**Pipeline and Hazardous
Materials Safety
Administration**

Ref. No.: 14-0120

Subj: Letter of Interpretation - Request DOT Concurrence with U. S. Navy Proposed Packaging Method for BF3 Neutron Detector

Figure 5-1. Radiac Probe, Exploded View

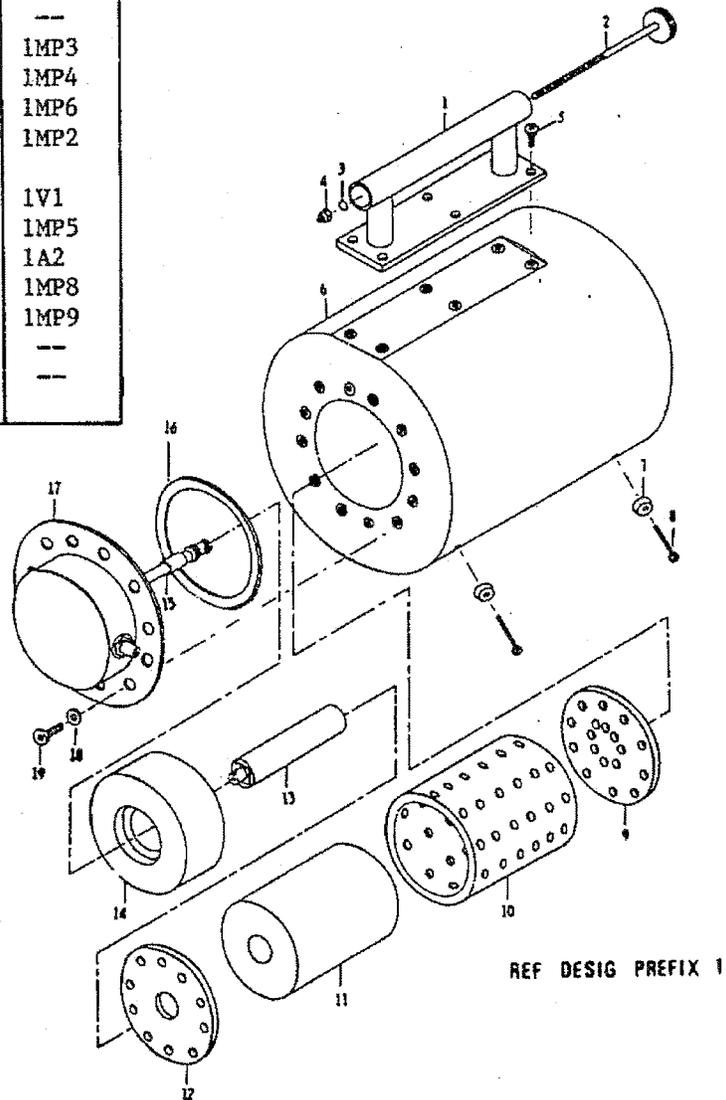
You describe the construction of a neutron radiation detection system and your proposal to place a sufficient quantity of activated alumina or activated carbon desiccant within a sealed outer moderator that also acts as the outer case of the system. The outer moderator which is made of polyethylene also encases the detector probe containing the boron trifluoride. You ask if this described method of packaging meets the intent of the requirements of paragraph a.(4) of Special Provision 238.

1. Background. Reference (a), Special Provision (SP) 238, was recently updated and provides new guidance for transporting neutron radiation detectors containing Boron Trifluoride (BF3) gas. The U.S. Navy uses a portable neutron radiation detector (AN/PDR-70) that utilizes a proportional counter (Reuter-Stokes/RSN-320-M2) containing less than 1 gram of BF3 gas at less than atmospheric pressure (60 cm/Hg). These detectors are now being transported under the new provisions per SP 238, paragraph c. This topic was discussed with DOT PHMSA's Office of Hazardous Materials Safety, Hazardous Materials Information Center (202-366-4488) who suggested the submission of a written request for interpretation via email or letter per 49 CFR 105.20.

As described, the neutron radiation detection system would meet the requirements Special Provision 238 paragraph a.(4) relating to the requirement for a liner surrounding the detector. The sealed polyethylene outer moderator would serve as the required liner.

Provided the radiation detector meets all other requirements of paragraph (a) of Special Provision 238 and the system is packaged in a strong outer packaging capable of withstanding a 1.8 meter (6-foot) drop without leakage, or the system itself, without packaging is capable of withstanding a 1.8 meter (6-foot) drop without leakage, the described radiation detection system is eligible for the relief from the HMR provided by paragraph (c) of Special Provision 238.
